BACK RIVER PROJECT
Responses to 2020 Annual Report Comments

July 6, 2021

Responses to 2020 Annual Report Comments

Modification Package Version 2-IMLE

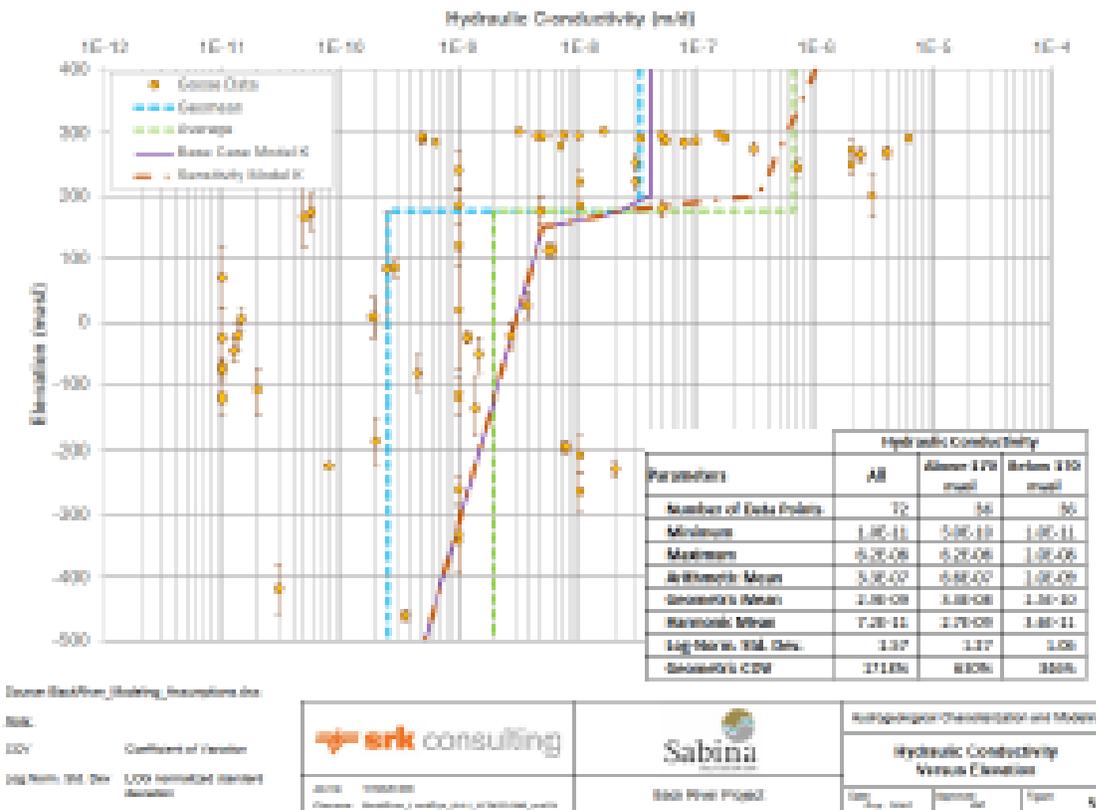
Increased mine depth

No hydraulic conductivity values have been collected deeper than approximately 750 m. We agree that the hydraulic conductivity values are expected to decrease with increasing in depth (see below, Hydrogeological Characterization and Modeling of the Proposed Back River Project - Figure 5 (Hydraulic Conductivity Versus Elevation)). However, it is important to note that the extremely low hydraulic conductivity values (10-11 m/s range) are associated with the estimated permafrost depth and are not necessarily reflective of the hydrogeological conditions below -150 masl where the hydraulic conductivity values are likely more consistent with the geometric mean below 170 masl value.

The consultant should clarify what hydraulic conductivity values are expected for the Umwelt Underground expansion to 900 m and what hydrogeological conditions are expected to be following the increase of the maximum excavation depth at Umwelt underground.

The Water Management Plan is currently under review as part of the Back River Project Type A (2AM-BRP1831) Water Licence Amendment Application currently subject to Final Hearings on July 13-14, 2021. Any further direction from the NWB Process will be incorporated into the Water Management Plan, and the approved plan will be provided to the NIRB for review.
